# Access Compliance Report

### (Curb Ramps)

Intersection ID: 18423	Main Street: ELESSAR_PL	Cross Street: STRIDER_DR	Location: SW
ADA ID: 6CC54245775C	Ramp Type: PerpDiag	Initial Pass/Fail: Fail	Overall Compliance: No
Codes/Mitigation Info/Possible Solution			Severity Score: 30
			Field Measurements/Component Compliance

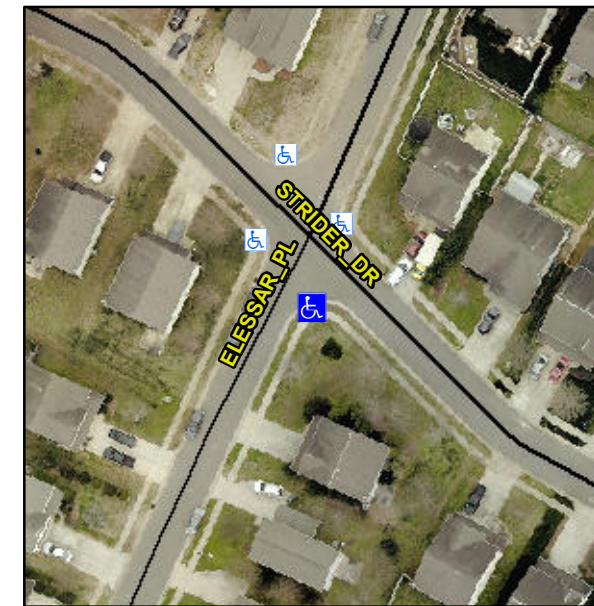
**R304.5.1, R304.5.3**

Compliance	Description	Data	Compliance	Description	Data
N/A	Ramp Length (in)	48.0	Yes	Ramp Slope (%)	6.4
No	Ramp Width (in)	35.0	No	Ramp XSlope (%)	6.7
N/A	Flare Type LT	N/A	N/A	Flare Type RT	N/A
N/A	Flare Slope LT (%)	N/A	N/A	Flare Slope RT (%)	N/A
N/A	Flare Traversable LT?	N/A	N/A	Flare Traversable RT?	N/A
N/A	Landing Length (in)	N/A	N/A	DWS Provided?	N/A
N/A	Landing Width (in)	N/A	N/A	DWS Contrast?	N/A
N/A	Landing Slope (%)	N/A	N/A	DWS Length (in)	N/A
N/A	Landing X Slope (%)	N/A	N/A	DWS Full Width?	N/A
N/A	Landing Curb? (Y/N)	N/A	N/A	DWS Offset (in)	N/A
N/A	Shared Landing?	N/A			
N/A	Gutter Ponding?	N/A	N/A	Gutter Slope (%)	N/A
N/A	Gutter Lip Ht (in)	N/A	N/A	Gutter X Slope (%)	N/A
N/A	Painted X Walk1?	No	N/A	Painted X Walk2?	No
	X Walk 1 Direction	To NE		X Walk 2 Direction	To NW
N/A	X Walk 1 Width (in)	N/A	N/A	X Walk 2 Width (in)	N/A
	X Walk 1 Slope (%)	2.1		X Walk 2 Slope (%)	4.9
	X Walk 1 X Slope (%)	3.2		X Walk 2 X Slope (%)	5.3

**Remove & Replace Curb Ramp With Two New Directional Ramps or Equivalent.**
